**Corrective Action Plan – Soil and Mine Wastes, Revision 1
Three Kids Mine
Lakemoor Ventures LLC**

Re: Corrective Action Plan – Soil and Mine Wastes, Revision 1
Three Kids Mine

Appendix A	Three Kids Mine Remediation and Reclamation Act
Appendix B	Response to Comments
Appendix C	Asbestos Abatement
Appendix D	Corrective Action Schedule

Figure 8-1	
Closure Units	
Three Kids Mine	
Designed	
Drawn	JCM
Approved

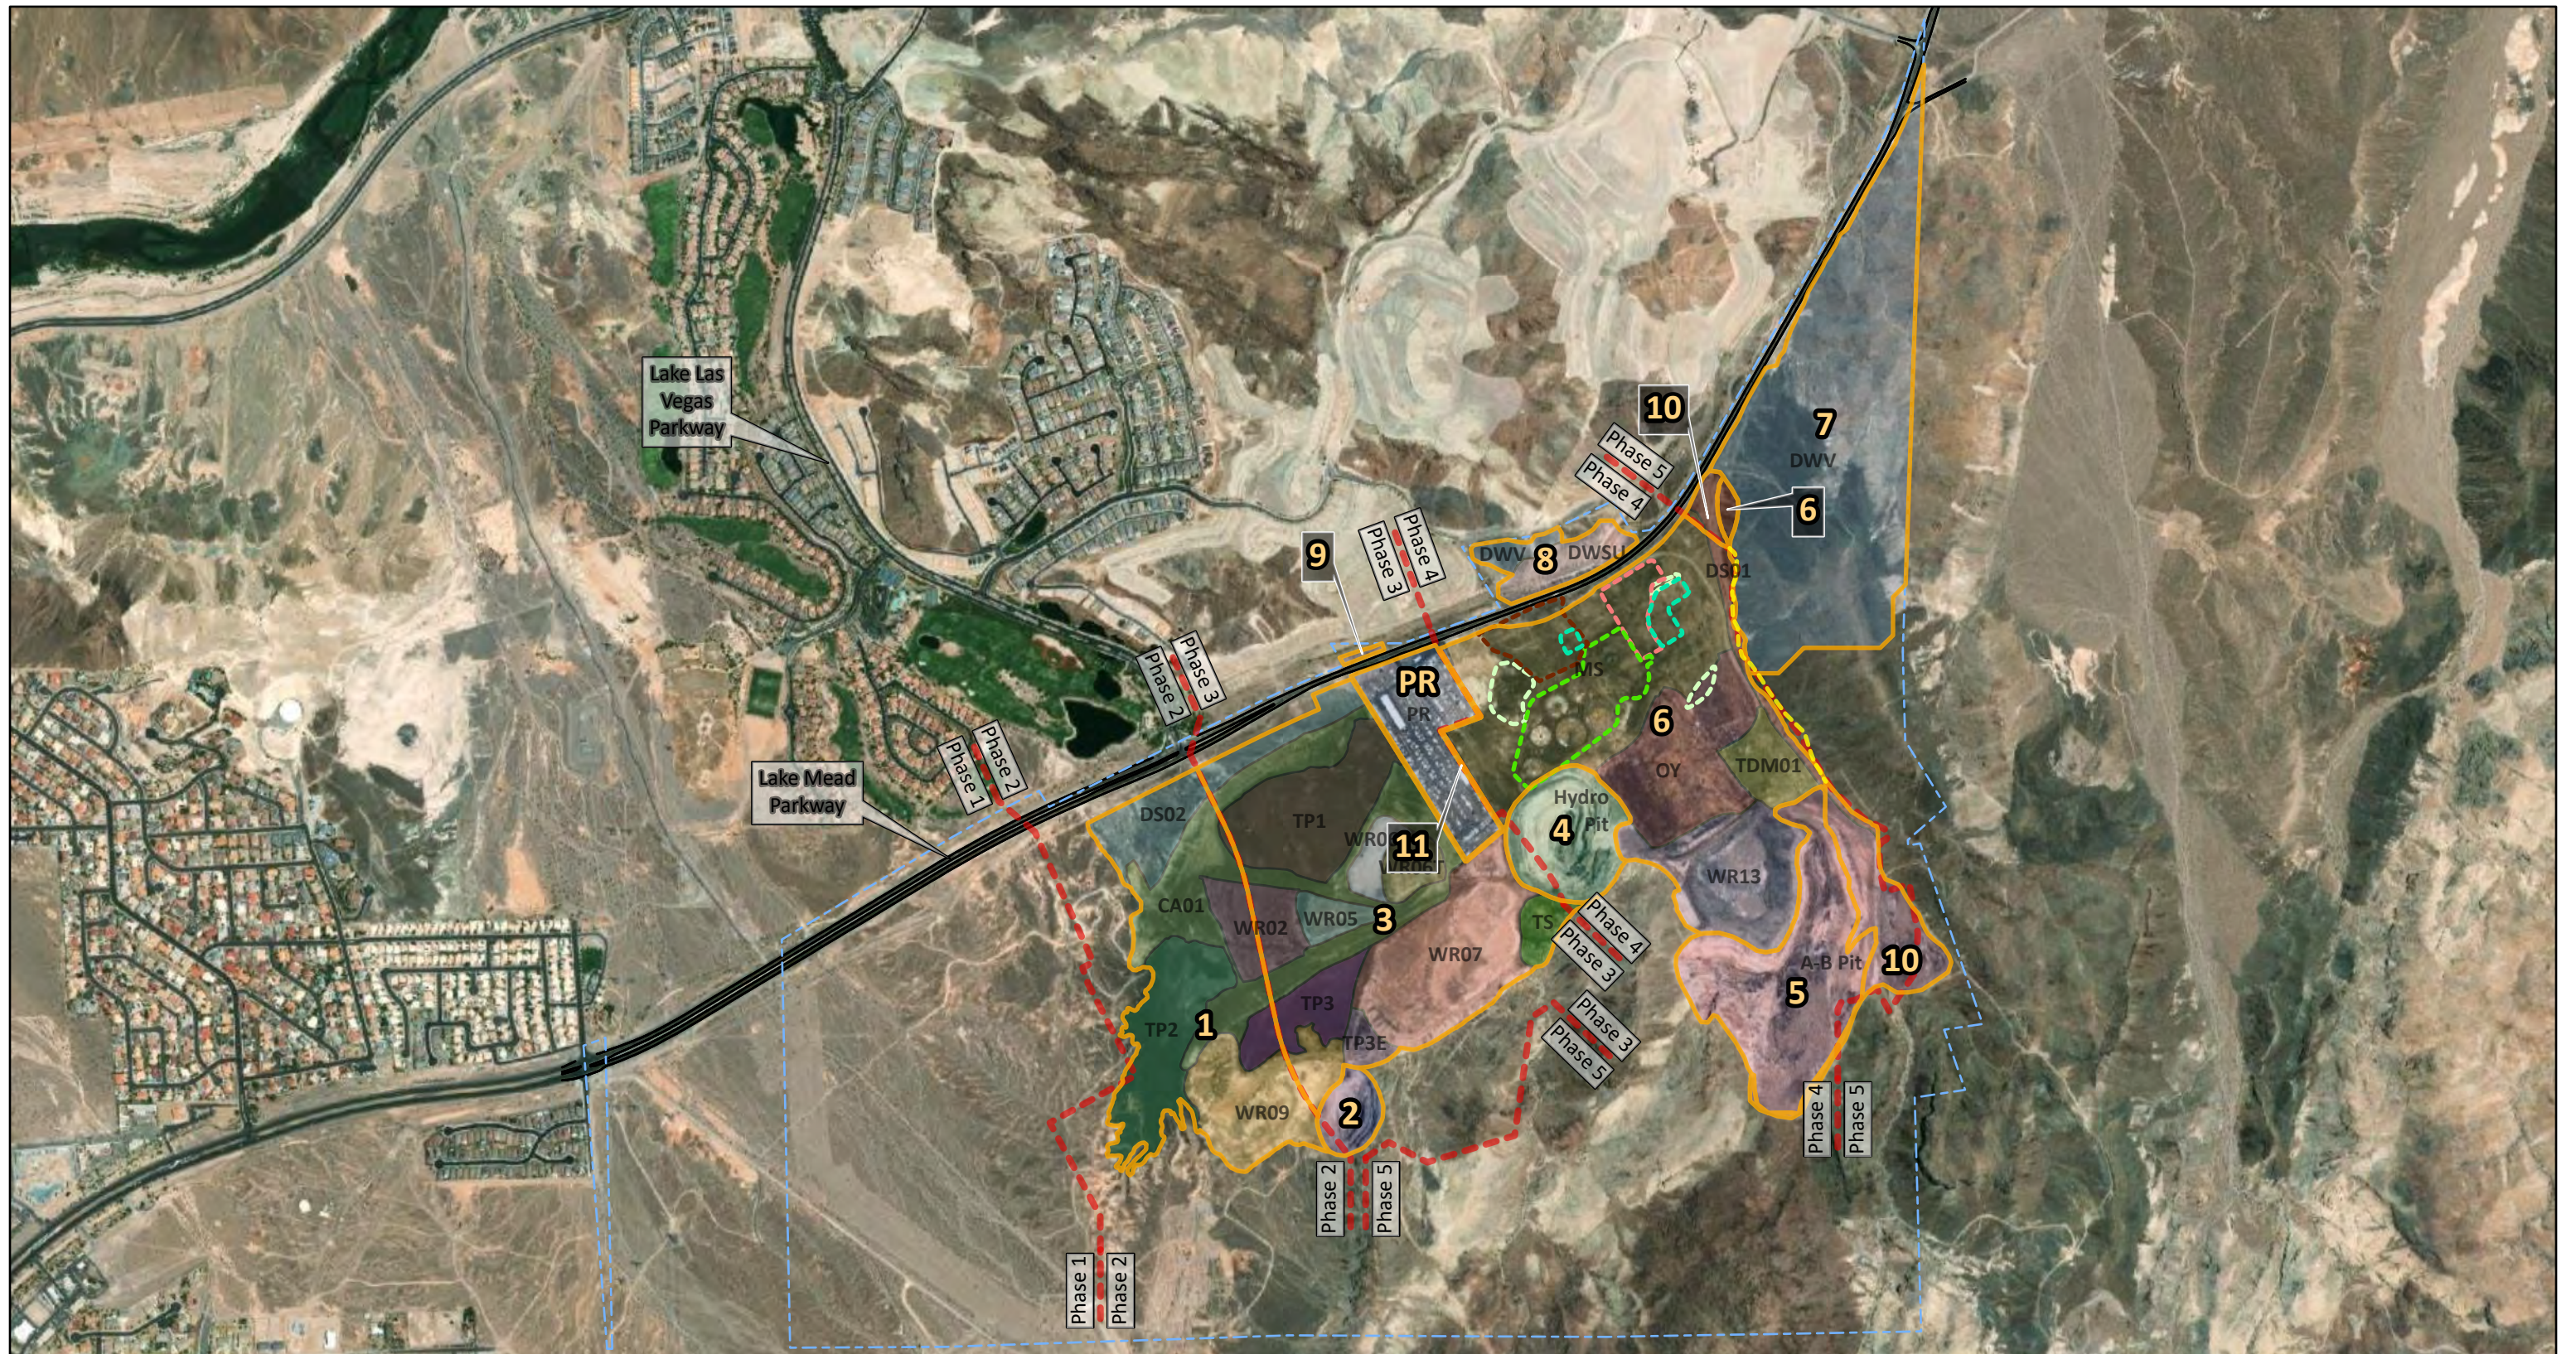
45. **Figure 5-7 Stormwater Basins and Figure 8-1 Closure Units** – Figure 8-1 show the borrow area to the east to be Closure Unit 7. Figure 5-7 shows the borrow area to the west will be developed yet it has not been designated as a Closure Unit. Please clarify.

The borrow area to the west is not part of the former mine site and is considered background (see Figure 1-3).
